ARCHITECTURAL REVIEW BOARD STAFF REPORT

Project #/Name	ARB-2024-61: Holly Hills Development Phase I – Final
Review Type	Final Site Plan and Preliminary Review of Architecture
Parcel Identification	04600-00-00-028A0, 04600-00-00-028B0, 04600-00-00-028E0, 04600-00-00-028F0, 04600-00-00-028I0, 04600-00-00-028J0, 04600-00-00-028K0, 04600-00-00-028L0
Location	East side of Rt. 29, south of South Hollymead Dr. (See Figures 1 and 2.)
Zoned	Planned Residential Development (PRD) / Entrance Corridor (EC)
Owner/Applicant	Frances B & Willard Howard Birkhead Family Trust Etal (46-28B,46-28I, 46-28J, 46-28K), Old Palmyra Hotel LLC (46-28F, 46-28L), Rebecca Wall (46-28E), Cynthia T Zoulis 46-28A / Collins Engineering (Chuck Rapp)
Magisterial District	Rivanna
Proposal	To construct the first phase of a residential development with approximately 318 apartments in 6 buildings, with associated site improvements.
Context	The properties are either occupied by houses and associated outbuildings or are vacant. The Forest Lakes neighborhood, with a mix of single-family attached and detached dwellings, is located to the east and southeast. The Brookhill development is situated to the south across Ashwood Bl

Figure 1: Project site near the intersection of Rt. 29 and South Hollymead Dr.

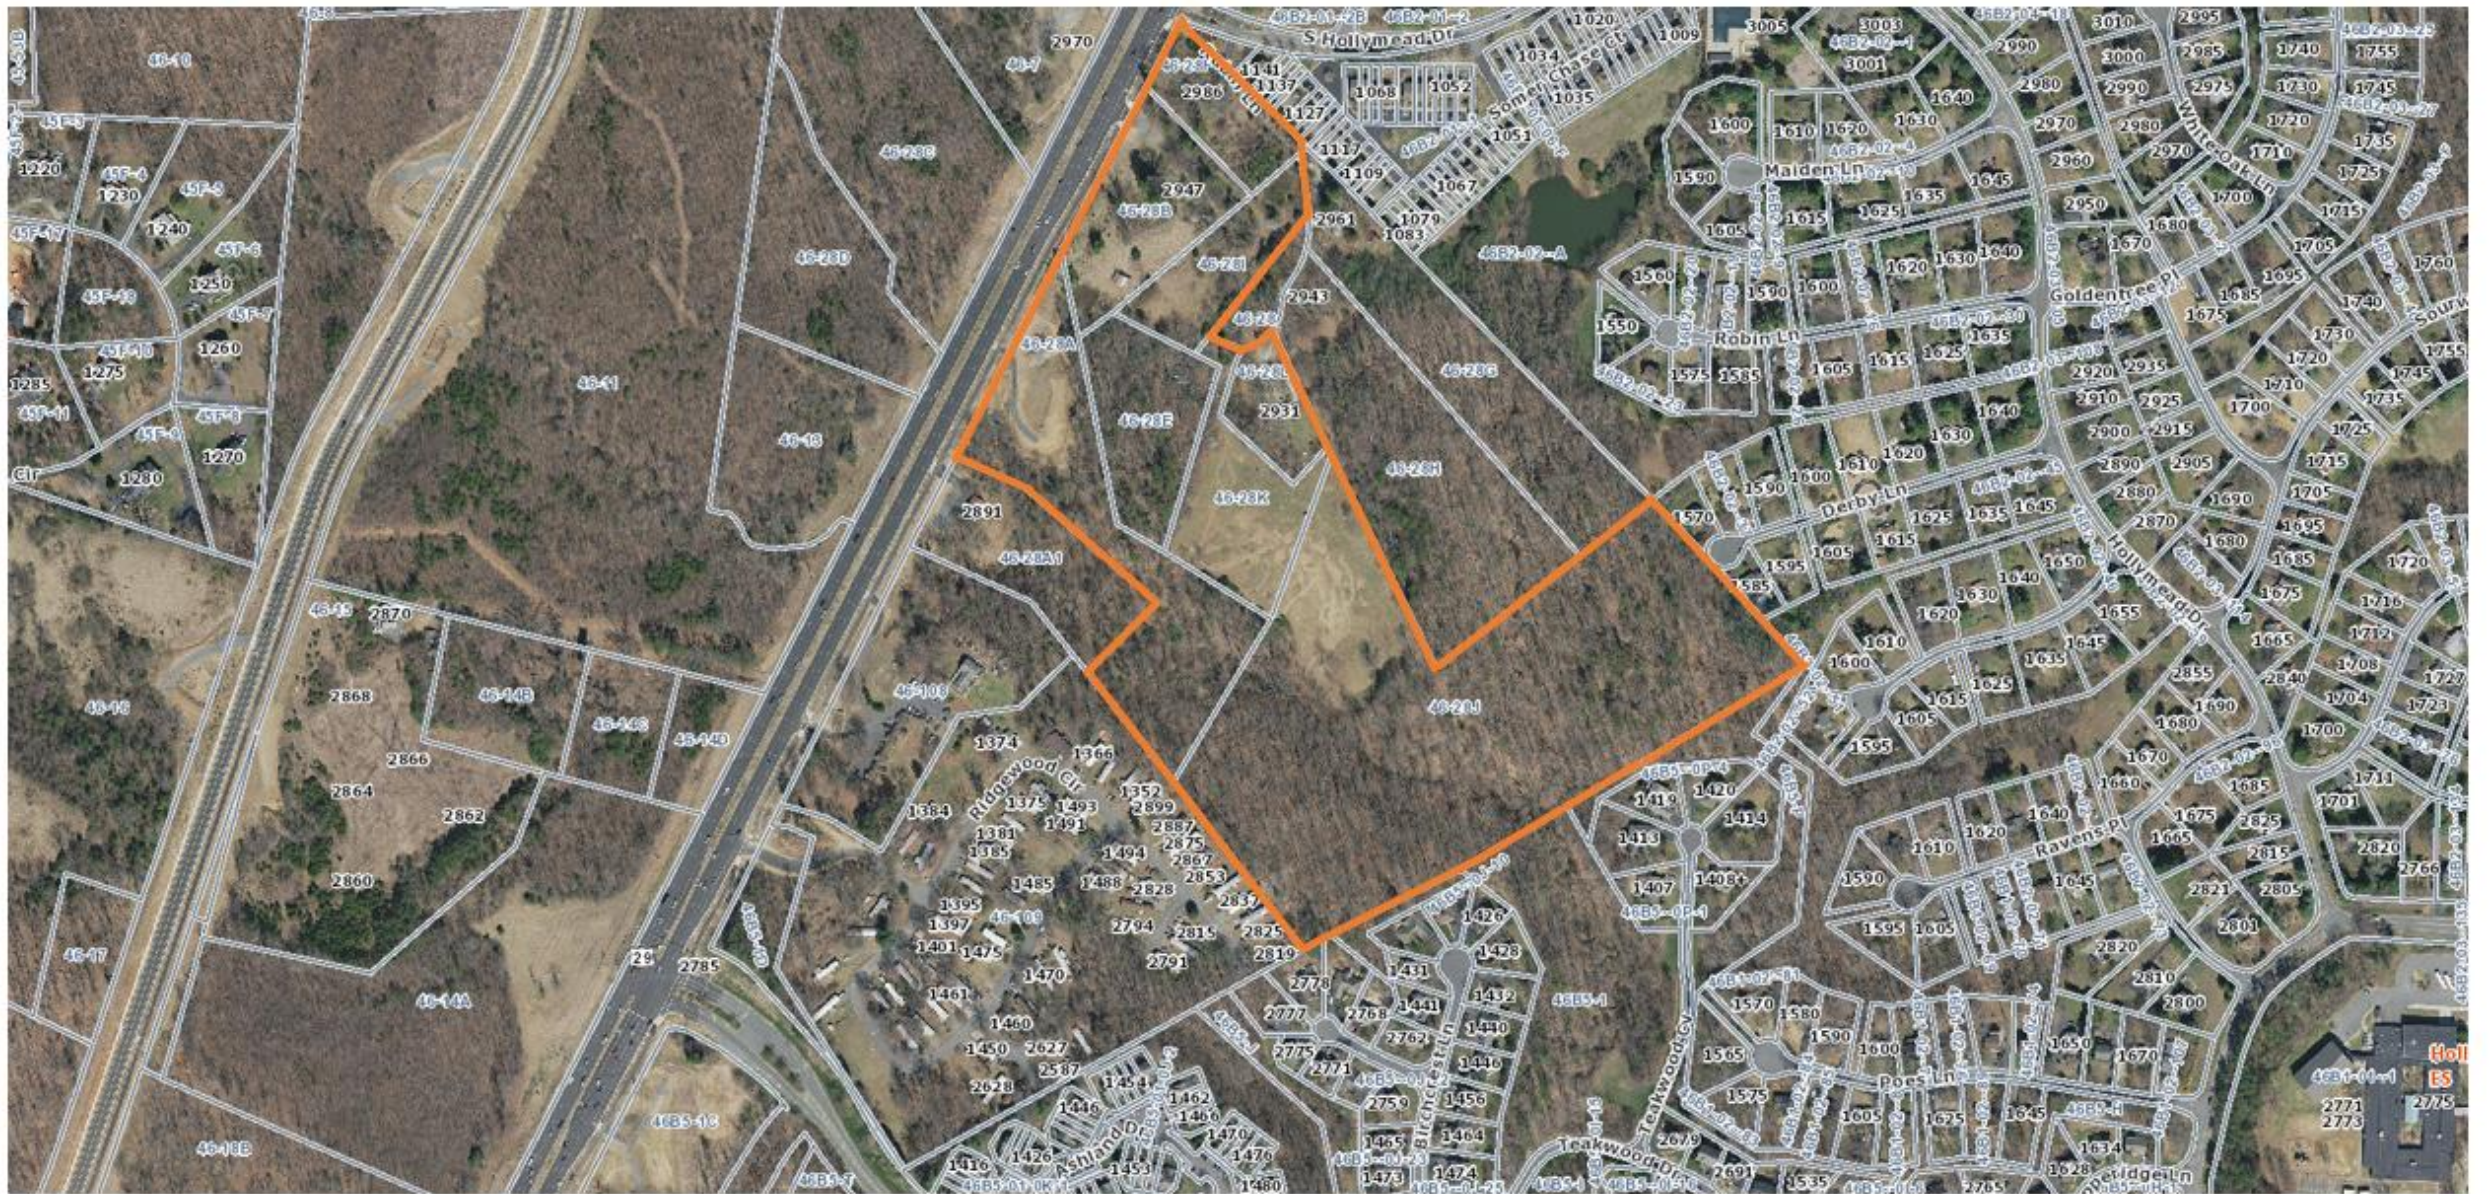
Visibility	<p>A landscape buffer is proposed along the Rt. 29 frontage at a depth of 100' (70' undisturbed, 30' landscaping). The vegetation in the 70' portion appears sparse and the 30' portion allows for grading. The updated landscape plan shows new trees being planted in both portions of the buffer; however, they will take years to mature, so the apartment buildings will be visible once built and for years to come. Buildings 1, 2, 3, and 4, at 3- to 4-stories tall, will be visible through and beyond the trees. Visibility of Buildings 5 and 6 will be available from the intersection of Rt. 29 and Archer Avenue.</p> <p>The Phase II and III townhouse blocks at the back of the property are not expected to have a significant visual impact from the EC street due to distance and topography, and because most are located behind the apartment buildings as viewed from the EC.</p>
ARB Meeting Date	November 4, 2024
